From: [Yu, Olivia, EMNRD](#)
To: [Geoff Leking](#); ["Mann, Ryan"](#)
Cc: ["Ralph Tijerina"](#); shane@etechemv.com; kim@etechemv.com
Subject: RE: Goodnight Former DCP Pump Station Historical Release 1RP-5091 Corrective Action Plan Modification
Date: Tuesday, August 7, 2018 9:33:00 AM
Attachments: approved_1RP5091_8.6.18 corrective action plan modification.pdf

From: Geoff Leking <geoff@etechemv.com>
Sent: Monday, August 6, 2018 3:45 PM
To: Yu, Olivia, EMNRD <Olivia.Yu@state.nm.us>; 'Mann, Ryan' <rmann@slo.state.nm.us>
Cc: 'Ralph Tijerina' <rtijerina@goodnightmidstream.com>; shane@etechemv.com; kim@etechemv.com
Subject: Goodnight Former DCP Pump Station Historical Release 1RP-5091 Corrective Action Plan Modification

Former DCP Pump Station Historical Release

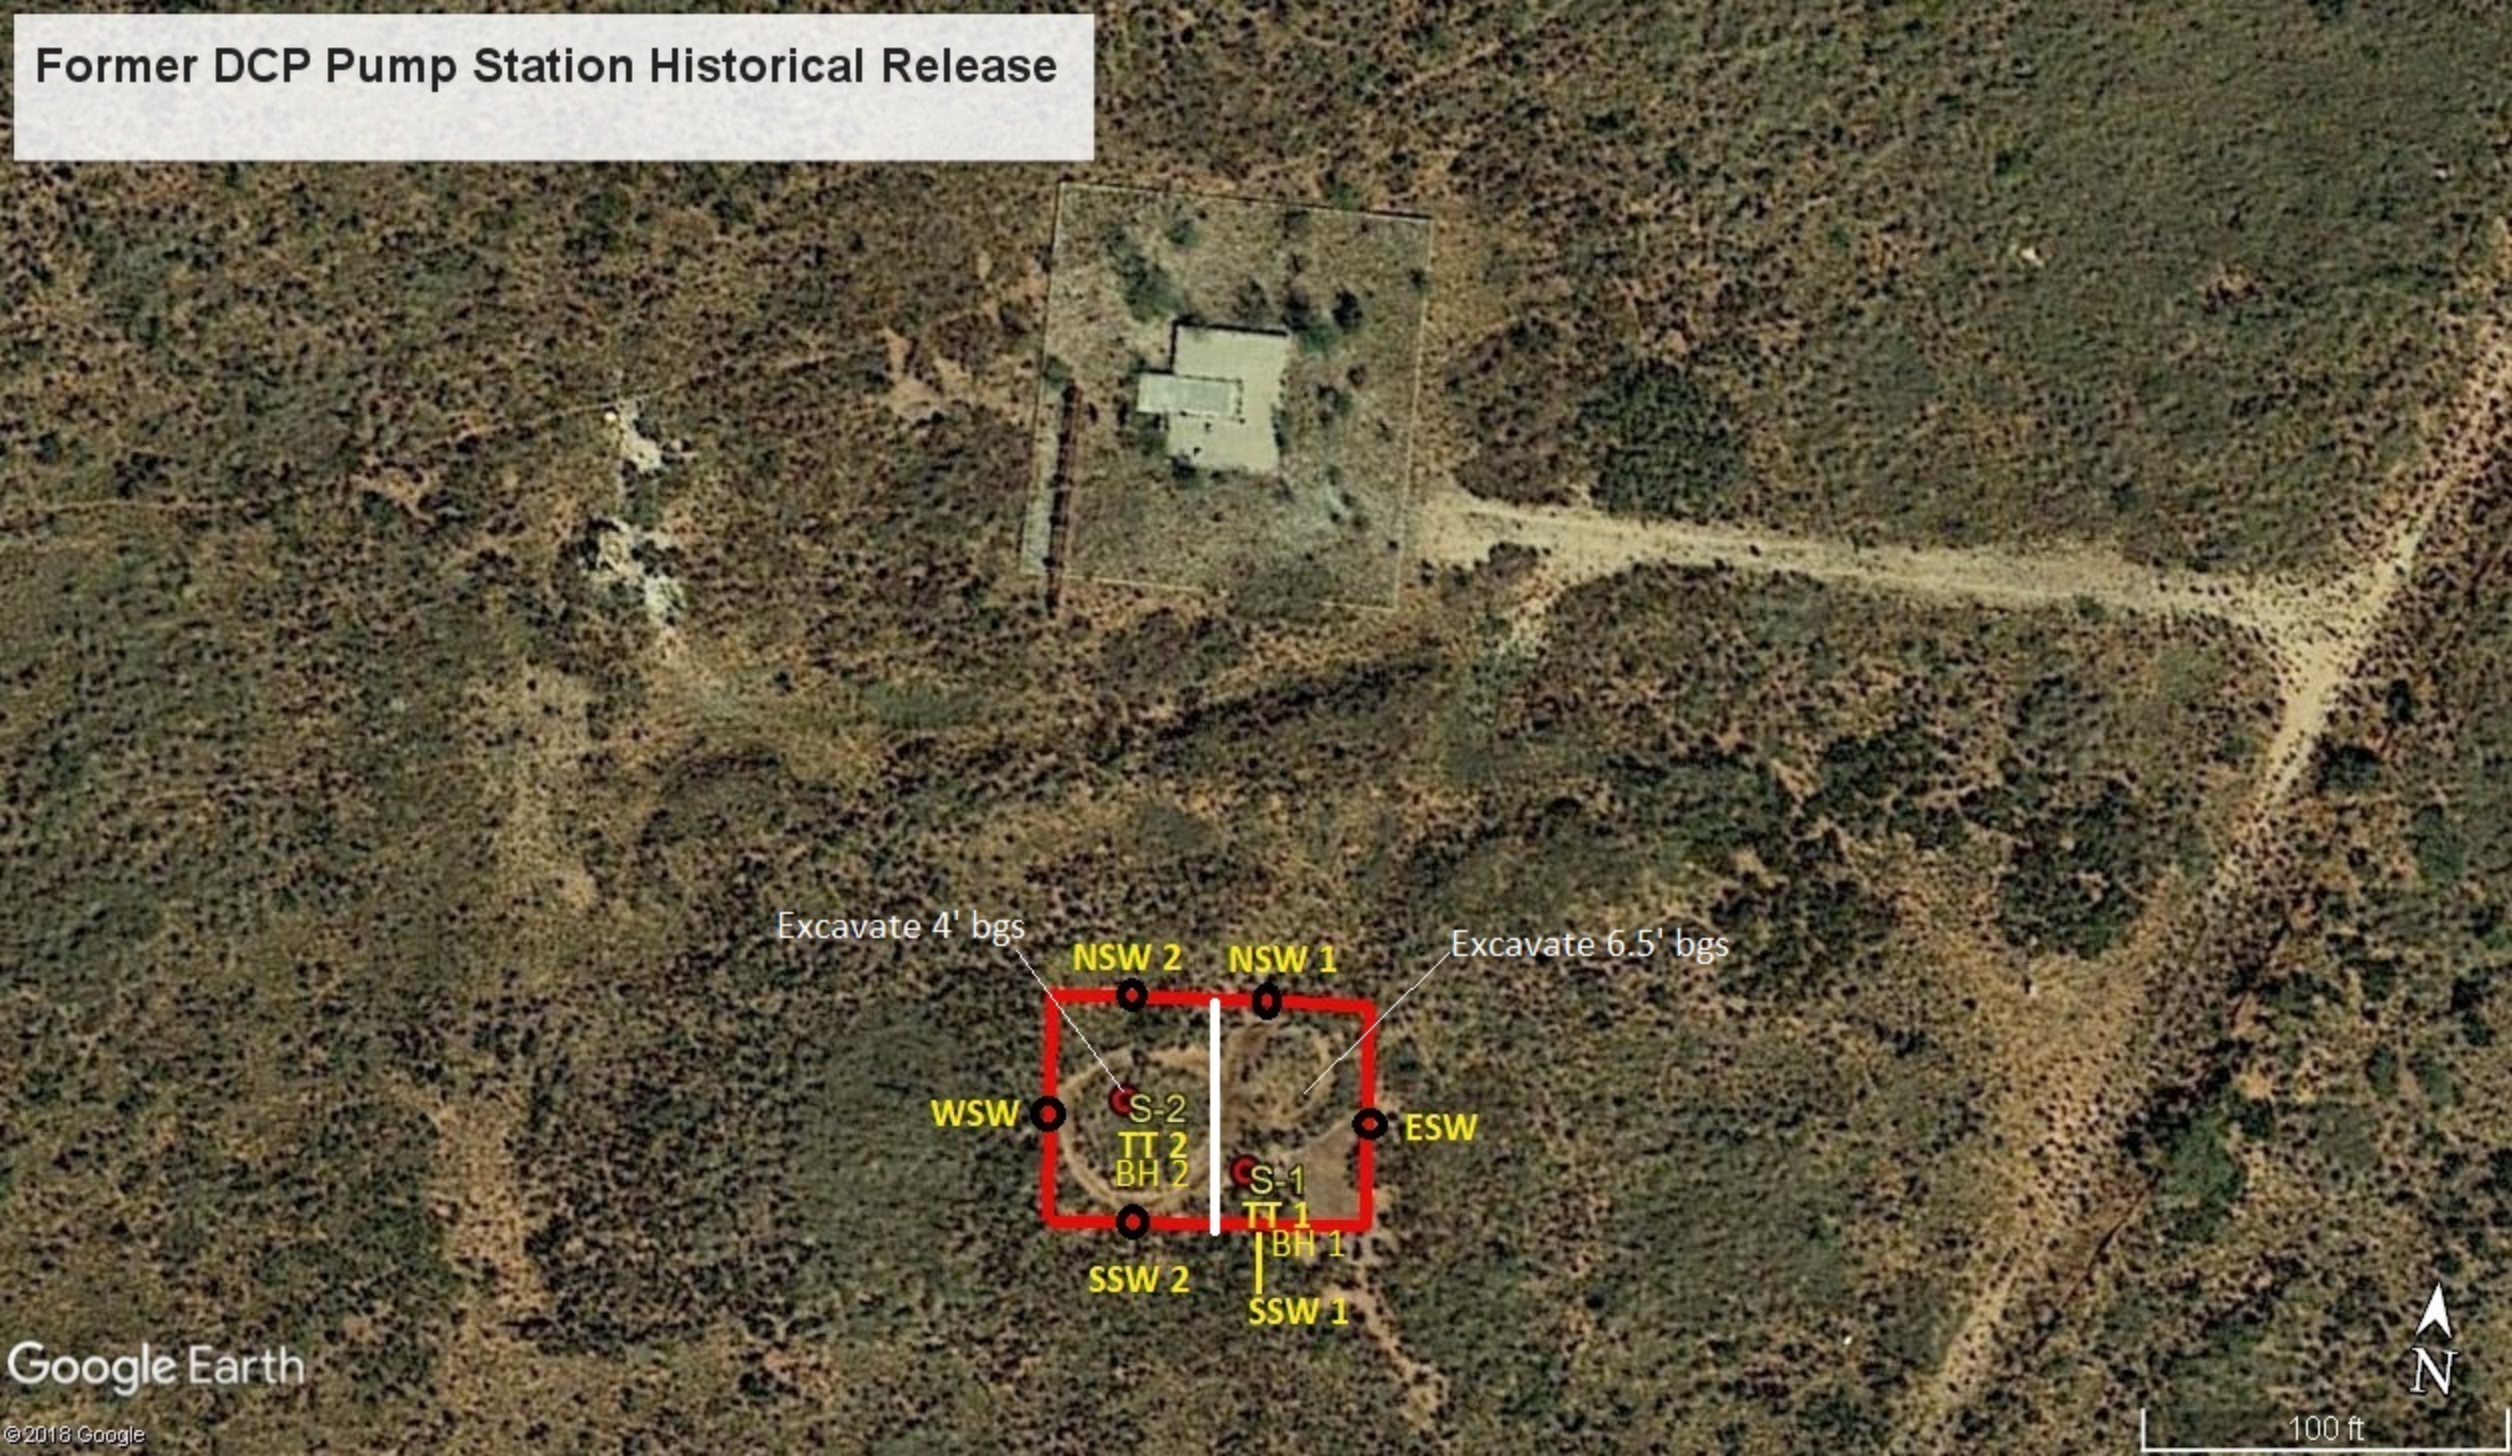
NMOCD will approved of the proposed remediation for 1RP-5091 with one clarification: one additional sidewall between the two different depths of excavation.

For further clarification of the areas to be excavated please see the attached image. The site will be basically split in half. I will place the image in the modification. Please contact me with any questions or concerns. Thank you.

The preference is to use field tests and precise calibration of instruments to guide which area is represented by TT-1 data and the extent of the area represented by TT-2 data. S-2/TT-2 area show hydrocarbon-impacted soil to at least 3 ft. A modification remediation proposal of 2 different depths of excavation is permissible.

- 1) Modified language in the Scope of Work that indicates the area associated with Test Trench 1 will be excavated to a depth of six and a half (6.5) feet below ground surface (bgs) and the area associated with Test Trench 2 will be excavated to a depth of four (4) feet bgs. In addition to the already planned six (6) sidewall confirmation soil samples, two (2) bottom hole confirmation soil samples will be collected.
- 2) Modified language in the Scope of Work that indicates the site will be reseeded with NMSLO Seed Mix Sandy Loam (SL) or NMSLO Seed Mix Sandy (S).
- 3) Modified Attachment B – Annotated Imagery displaying the proposed bottom hole confirmation soil sample locations denoted as BH 1 and BH 2.
- 4) The addition of Attachment E – NMSLO Seed Mixes.
- 5) Former Attachment E – Analytical Results is now Attachment F.
